Arlberg Ski Club Limited
Charlotte Pass NSW
PO Box 645
Annerley QLD 4103
Attention: Peter Brooks

Project 215619.00
15 September 2022
R.001.Rev0
MJJ

Preliminary Geotechnical Assessment
Proposed Additions
Arlberg Ski Lodge, Charlotte Pass Village

Sk4a

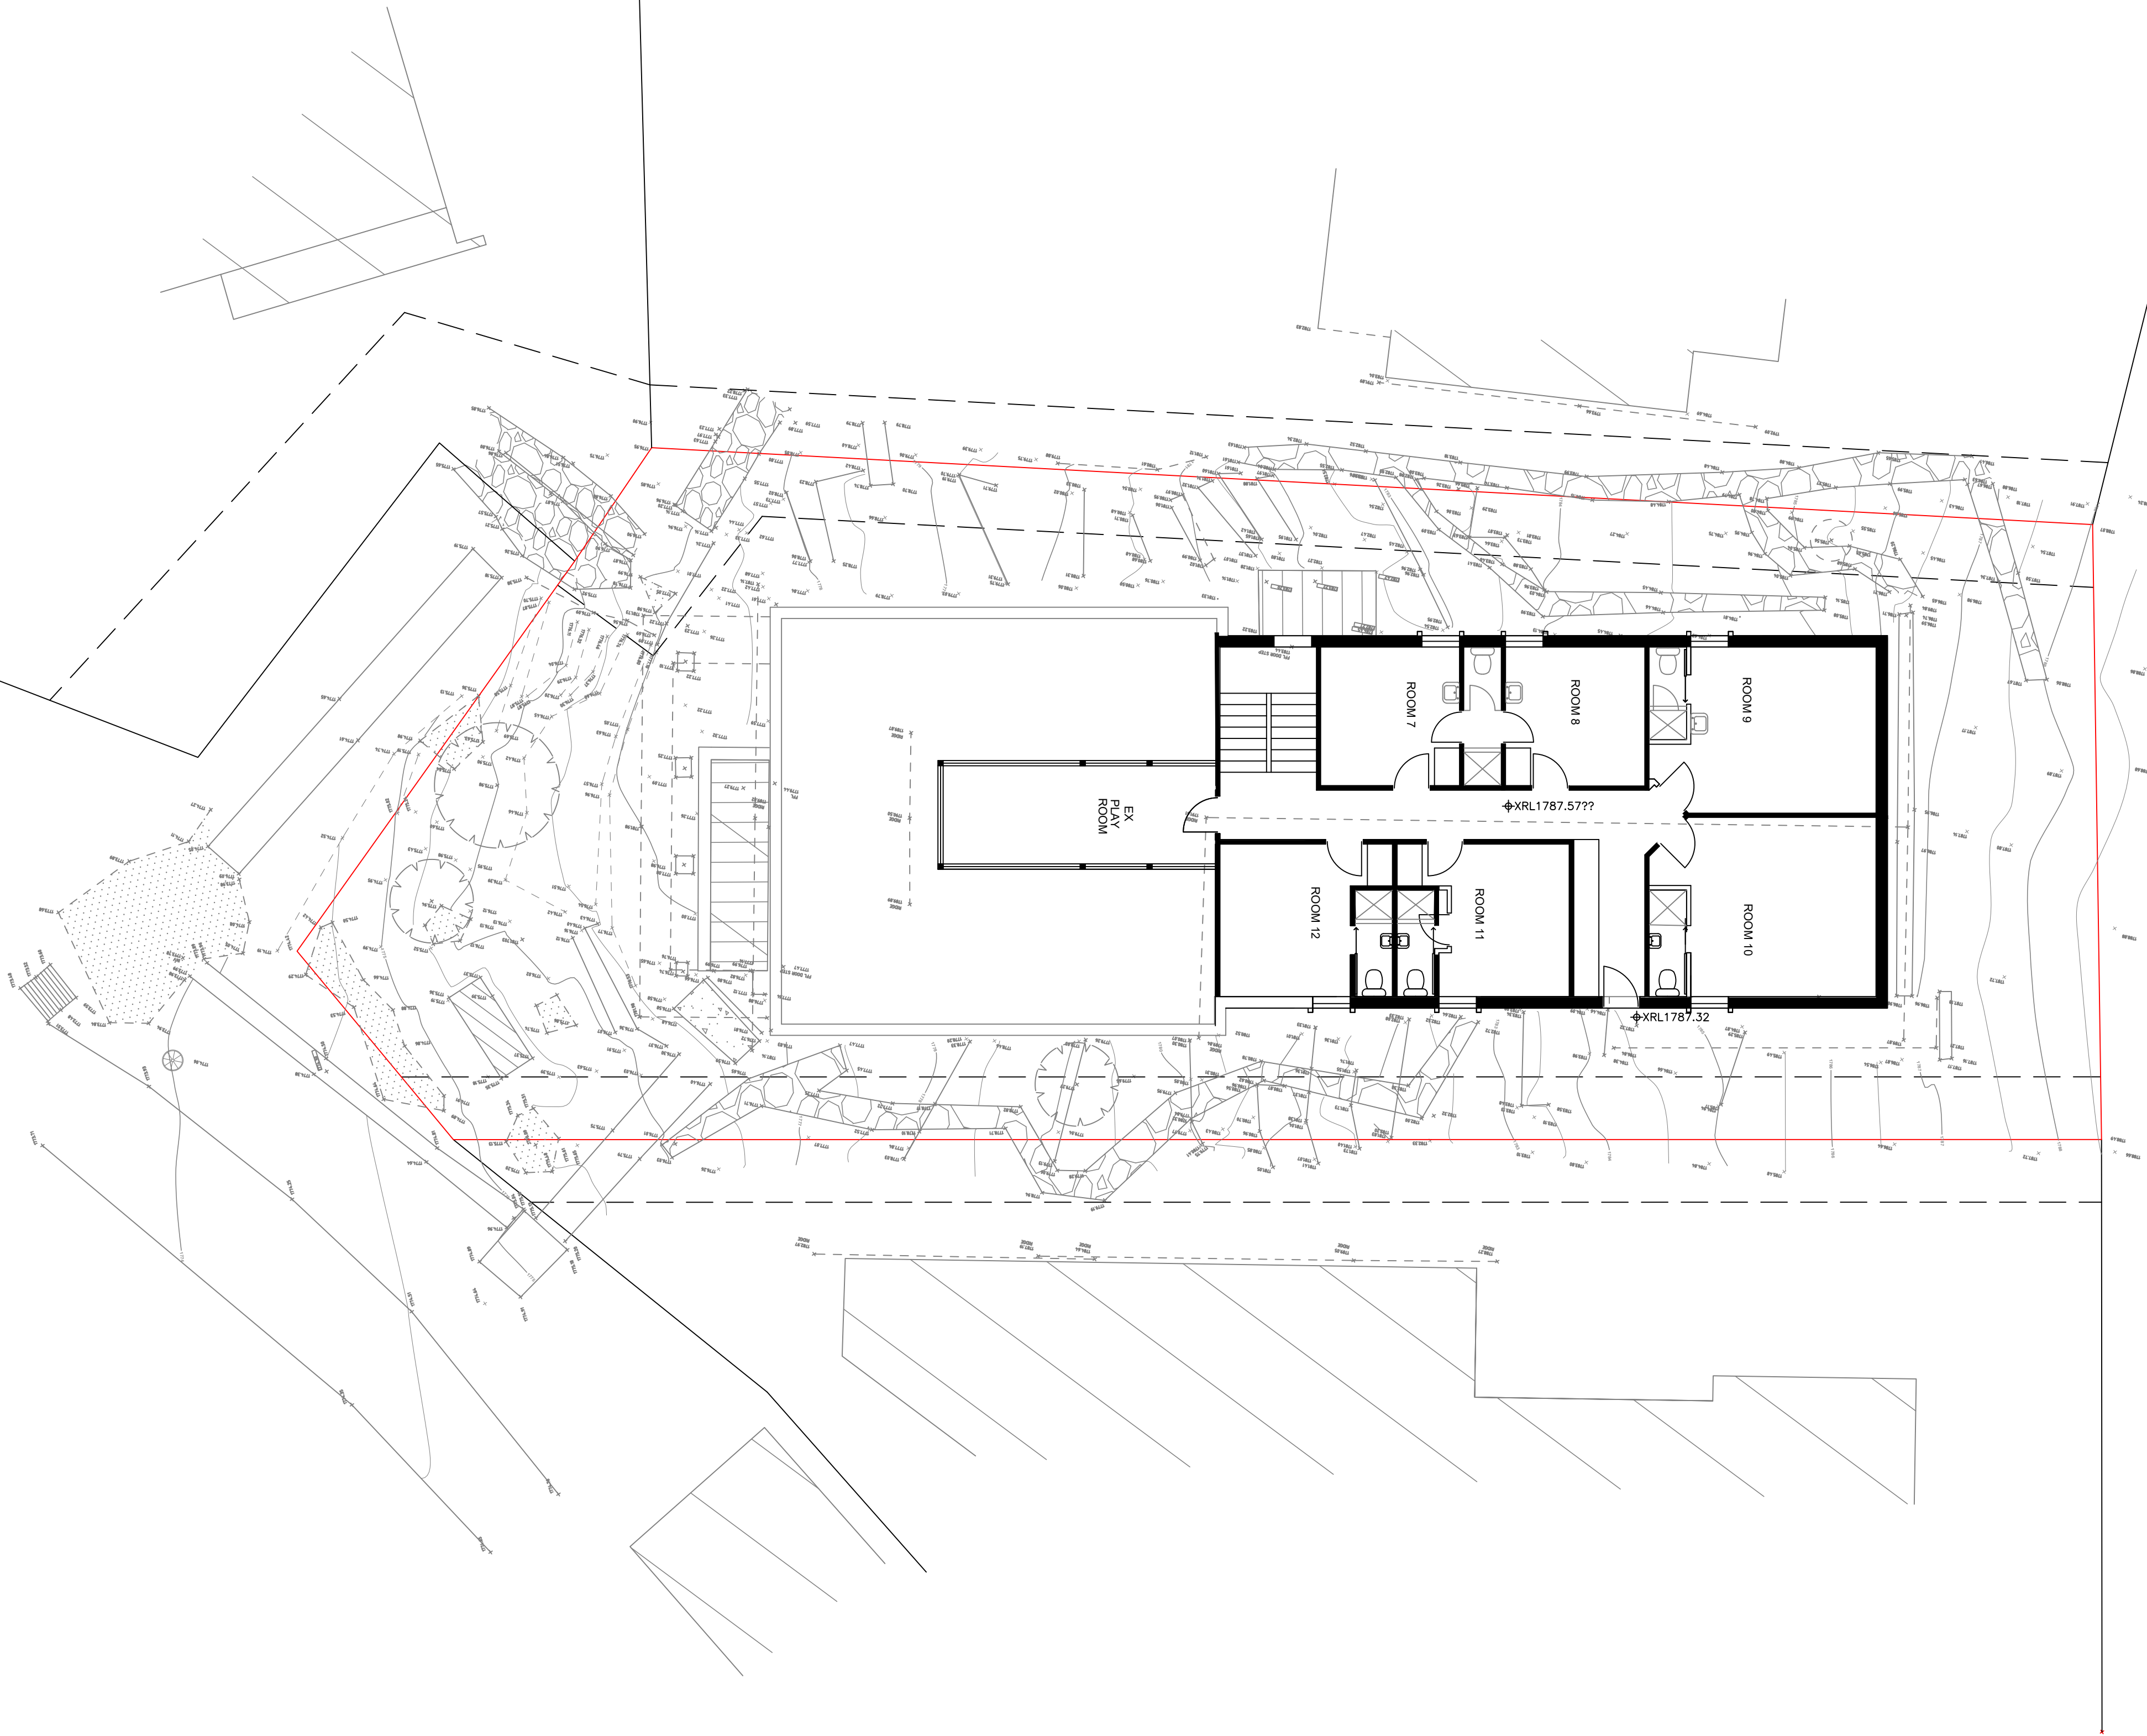
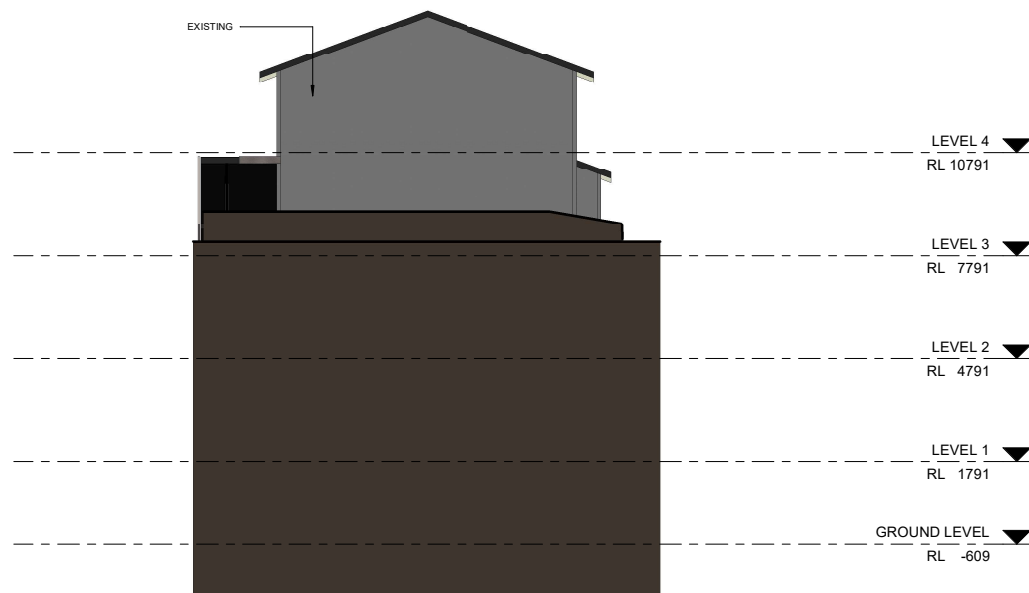
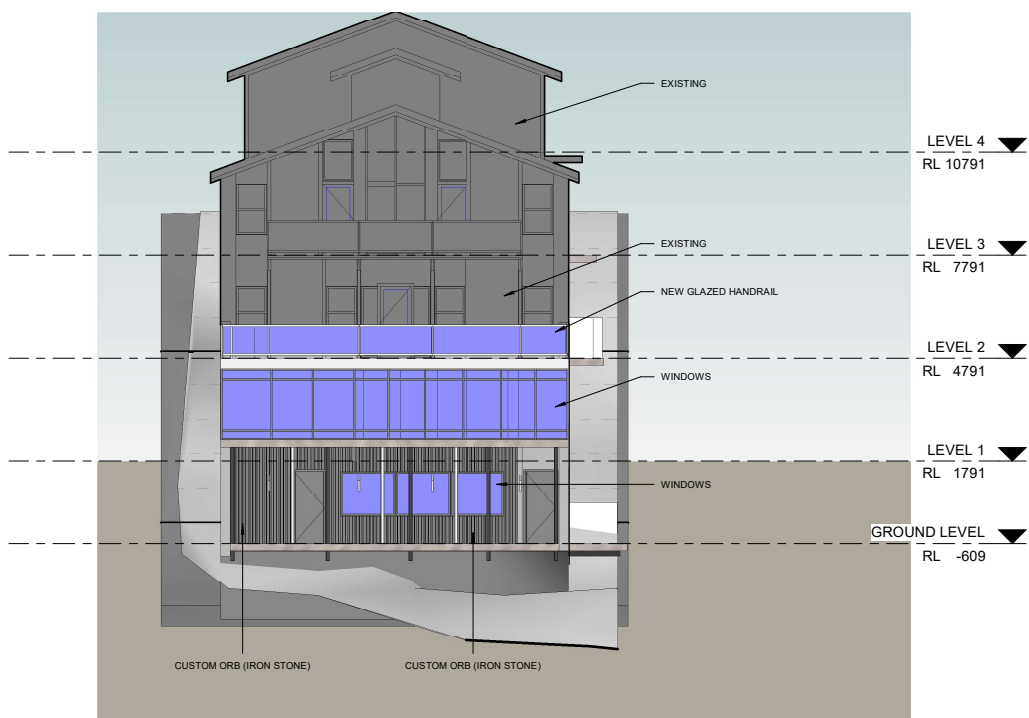
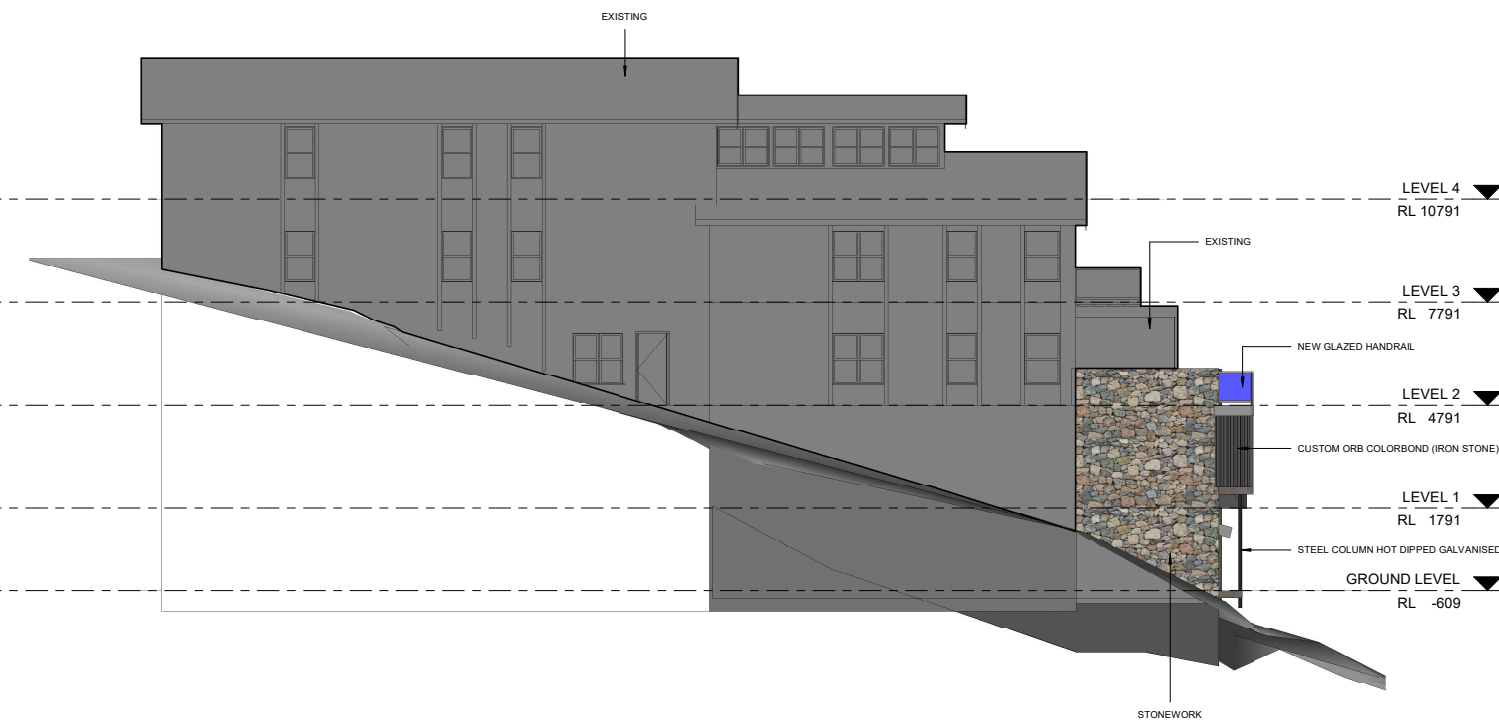
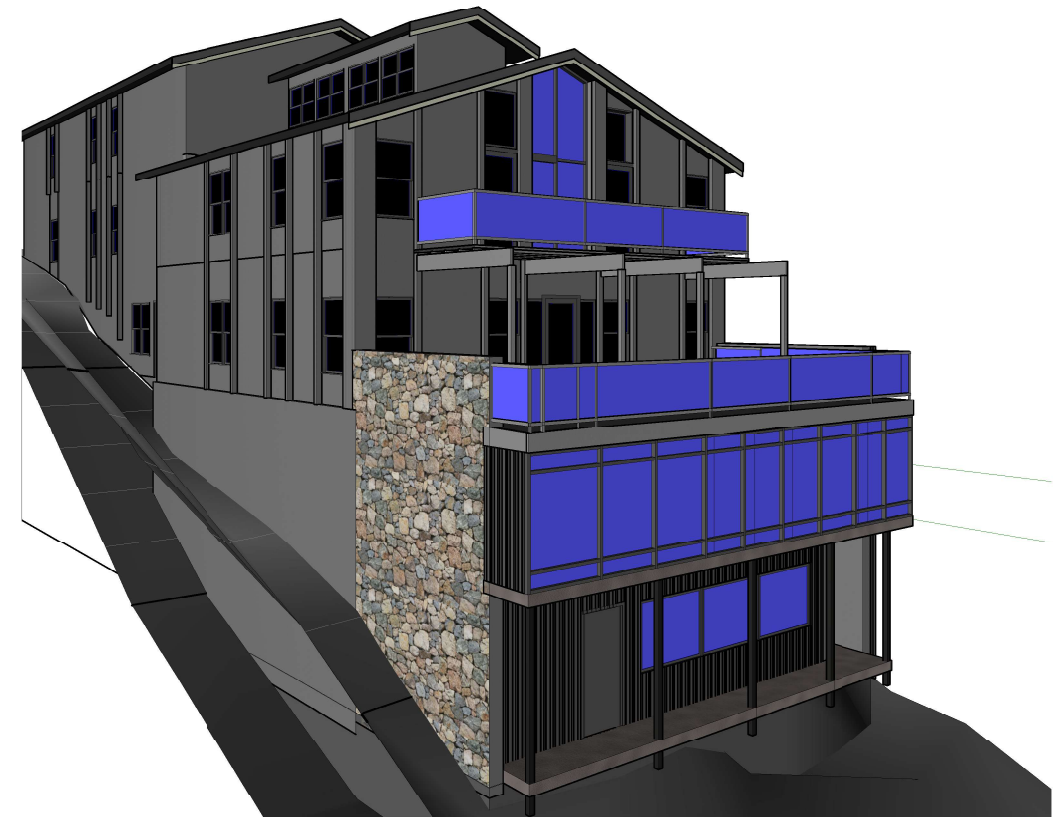
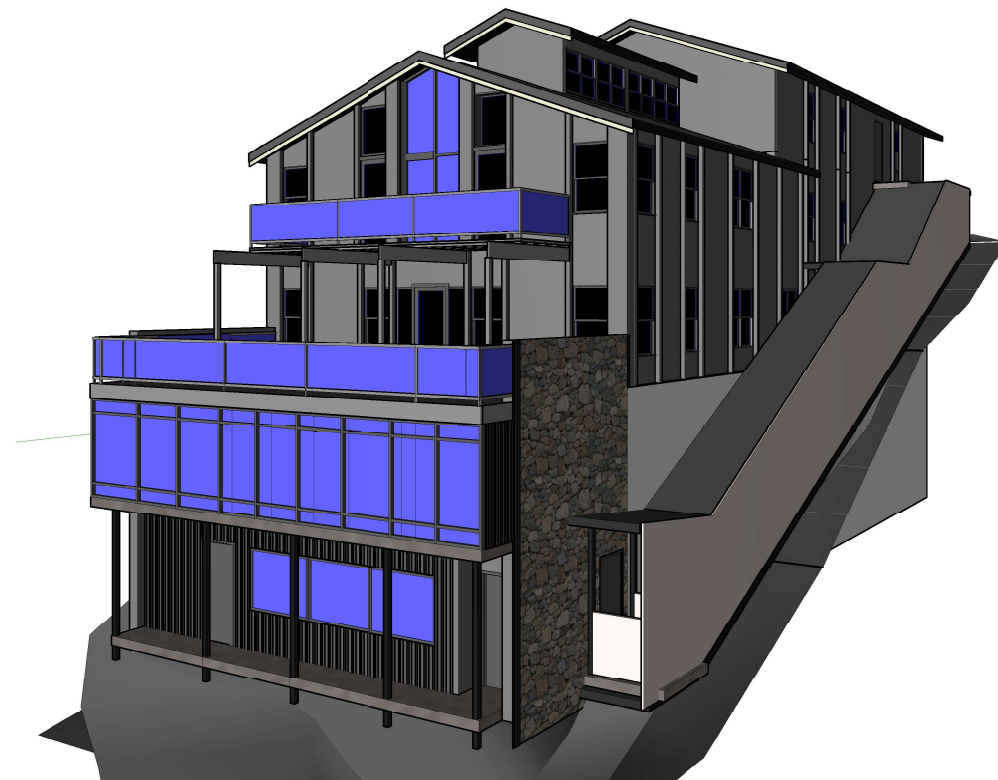
Site works as detailed in Drawings SK1a – SK7a dated 1 January 2021 (see attached drawings) indicate that a maximum depth of cut of 0.7 m and a maximum depth of fill of 0.9 m will be required to facilitate construction levels.

- All loads from the new structure including the lower ground floor slab are to be transferred through the overburden soils (possibly prone to soil creep) to within the weathered rock. A minimum socket of 0.5 m into weathered rock (minimum extremely low strength) is recommended with an allowable end bearing pressure of 300 kPa.
- All new footings must be founded below the zone of influence of any adjacent/existing footings or backfill trenches from buried services or underground storage tanks.
- Where required, fill must be compacted to at least 95% standard dry density ratio within 2 percentage points of optimum moisture content.

- The edges of any site excavation and/or fill required to establish the lower floor area must be supported by engineer designed retaining walls.
- All footing excavations must be viewed by a Geotechnical Engineer to confirm suitability of the founding stratum.
- Site surface drainage or and existing subsurface drainage systems must not be compromised by the proposed works.
- All stormwater and/or sewage that is generated by the new development must be disposed offsite in a controlled manner such that it does not impact the performance of the structure and/or surrounding ground.
